Infrastructure Feasibility Study

Arizona State Land Department

Union Pacific Railroad

Planning and Engineering Study

Exhibit 2 Context Area

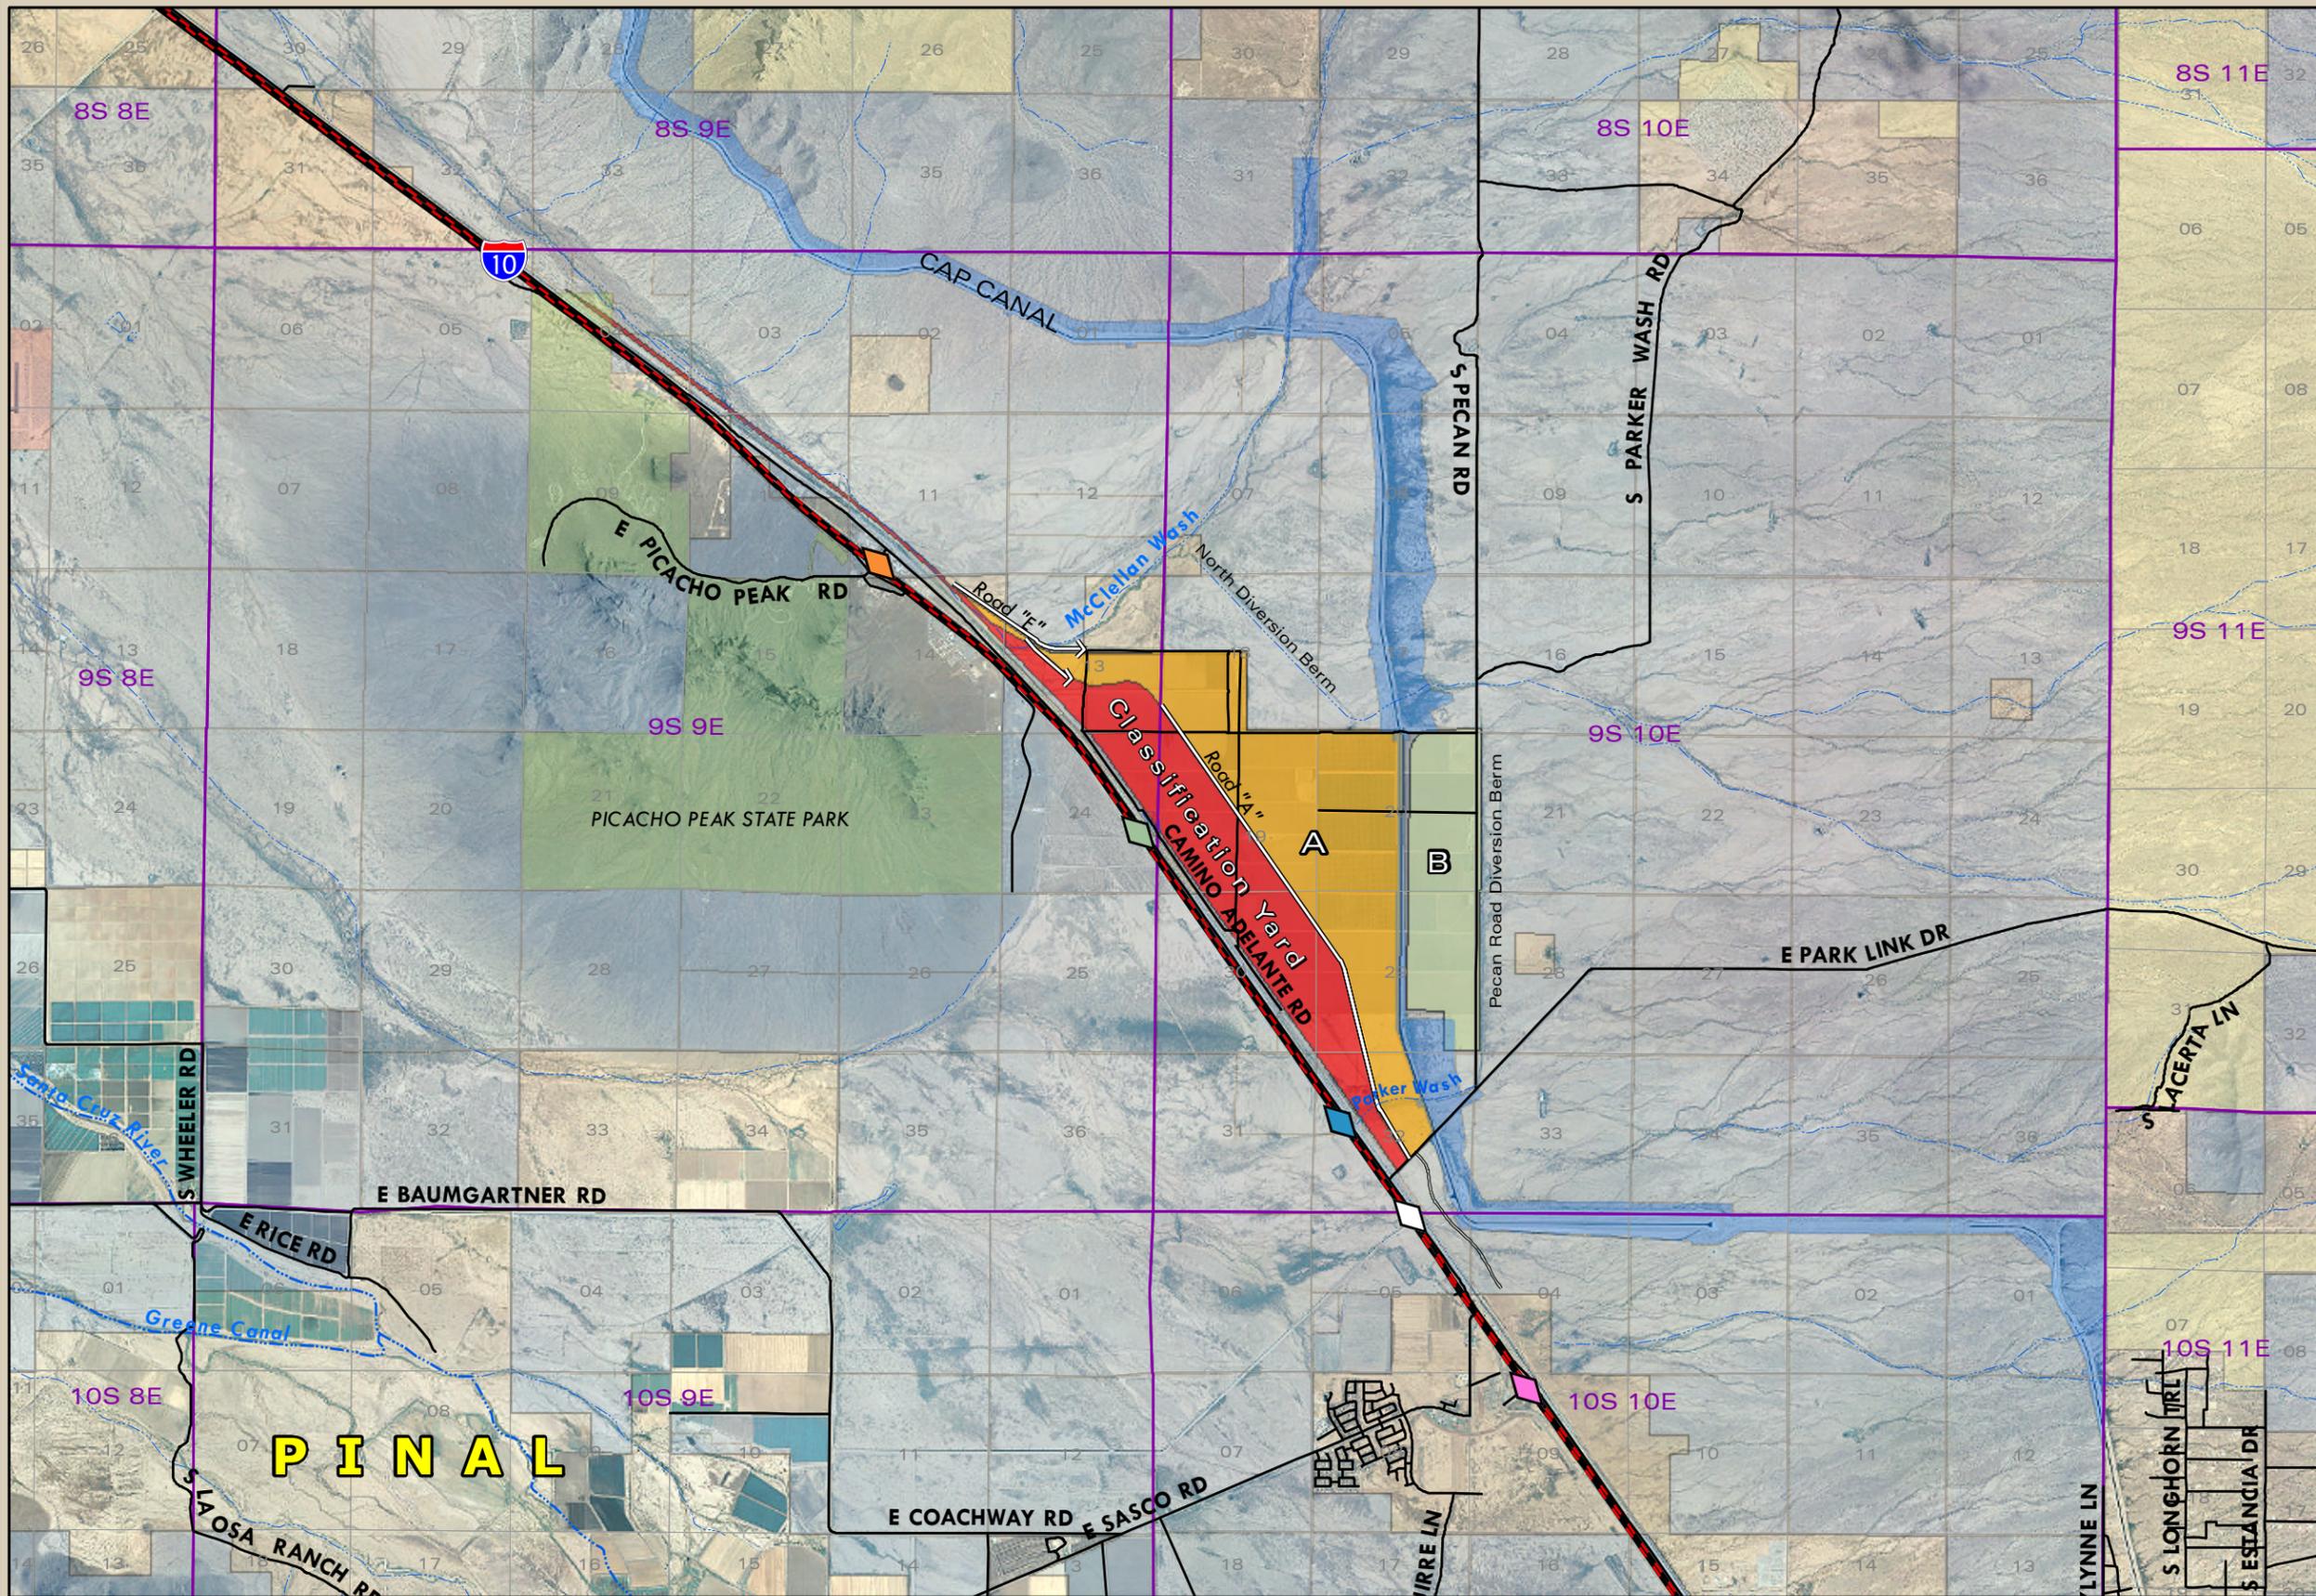
3. McClellan Wash is a delineated FEMA floodplain and the proposed improvements would alter the existing floodplain (See Exhibit 2). This would require preparation and submittal of a Conditional Letter of Map Revision (CLOMR) and Letter of Map Revision (LOMR). The CLOMR is preconstruction showing the proposed improvements and the LOMR is post construction using the as-built conditions. Procedure Memorandum 64 – Compliance with the Endangered Species Act (ESA) for Letters of Map Change states

Exhibit 3 Park Link

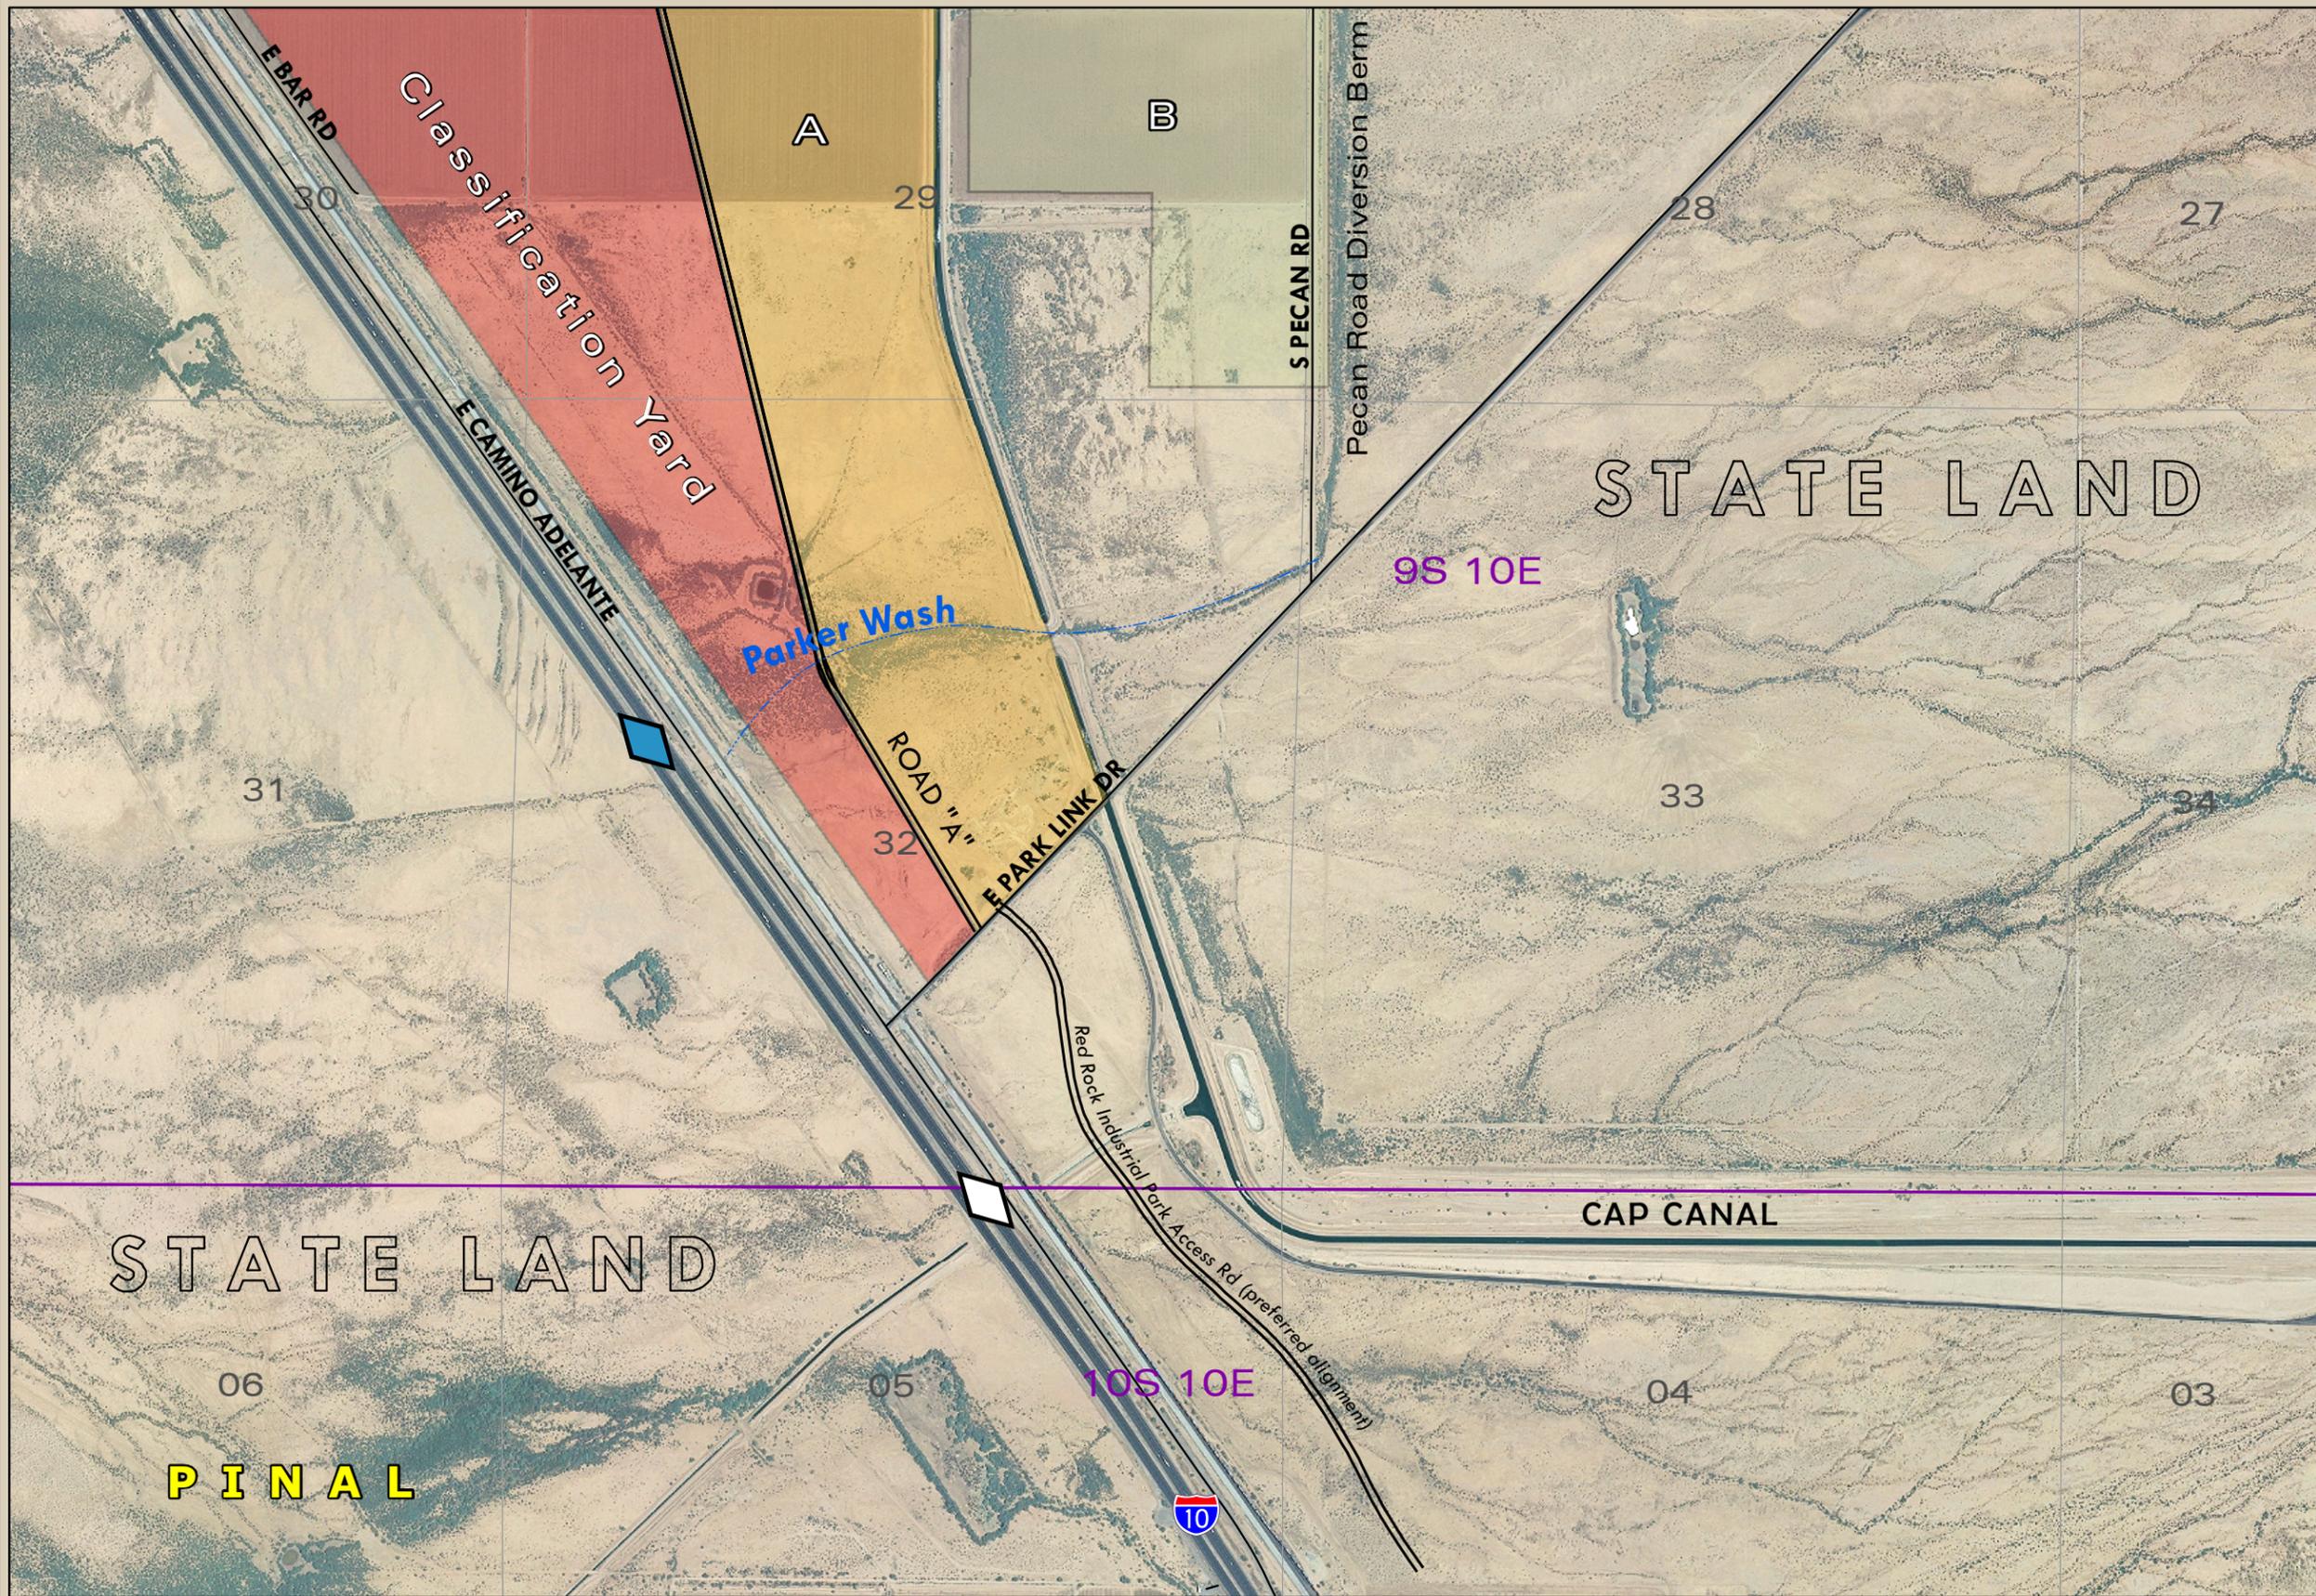
The DCR report for the I-10 widening identifies a proposed interchange location for the Park Link interchange as shown in Exhibit 3. While the I-10 DCR conceptually identifies a location for the Park Link interchange, ADOT does not have the Park Link interchange in their State Transportation Improvement Plan (“STIP”). ADOT considers the interchange as a developer driven and funded interchange. This means that the need for the interchange is determined by development, and the beneficiaries of the interchange are required to fund it. This is contrary to the statement in the URS Report, “ADOT also plans to construct a full interchange with I-10 at Park Link Drive.” ADOT planned for the interchange, but they have no funding identified or plan to construct it at this point.

5. The UPRR proposed location for the Park Link TI is approximately ½ mile away from the ADOT approved location (See Exhibit 3).
6. In the evaluation of the comparison between the ADOT preferred Park Link TI location and the suggested UPRR location(See Exhibit8), ADOT has advised that ADOT will not make a definitive ruling on this issue at this advanced planning stage in the process. It is our understanding that FHWA has allowed a deviation from its two-mile TI spacing requirement, but only minimal shifts as dictated by engineering design. To the best of our knowledge, FHWA has never approved a deviation to the extent being proposed by UPRR. This is based on a few factors:
